INDESIT company

Model type:
WI52EX

Commercial code:
F030502

1180170 Exploded views

n1040376: Drain pump with filter with pin.

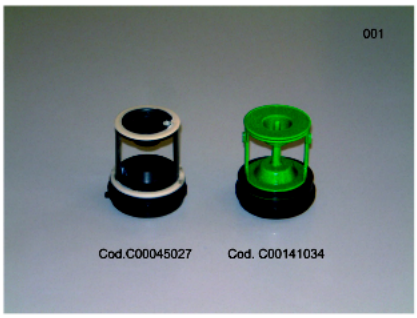
A new drain pump with filter with pin has been introduced progressively as from serial no. 50609.0001.

New parts:
C00119307 - Drain pump with pin filter;
C00141034 - Askoll / Plaset drain pump with pin filter kit (figure 001);

Premodification parts:
C00092264 - Drain pump;
C00045027 - Askoll / Plaset pump filter kit (figure 001);

The new parts can be used on all WASHING MACHINES previously equipped with the premodification parts.
